# P802.IQcc DI.0 COMMENT #47

CRAIG GUNTHER

13JUNE2016

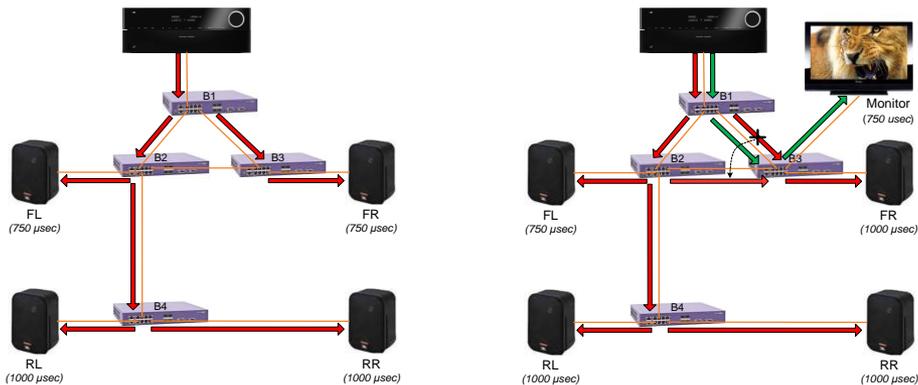
My concern is that during this upgrade process we will likely need to introduce segments of the network that must be manually configured with a UNI for features such as CB (redundancy). The UNI may also be used to configure the core of large networks, allowing SRP to run on edge segments.

So what will happen to the QoS of these networks when some portions of the network are running SRP and treat MaxLatency one way and other portions of the network are configured by the UNI and treat MaxLatency a different way (slide 5 item 2a vs. 2b)? Likewise what happens if an end-station switches to UNI control when it was running SRP previously?

I don't not want to allow a situation to occur where we are no longer certain about the QoS since the default behavior of MSRPvI with a UNI will be no latency guarantees unless EVERY end-station declares a MaxLatency.
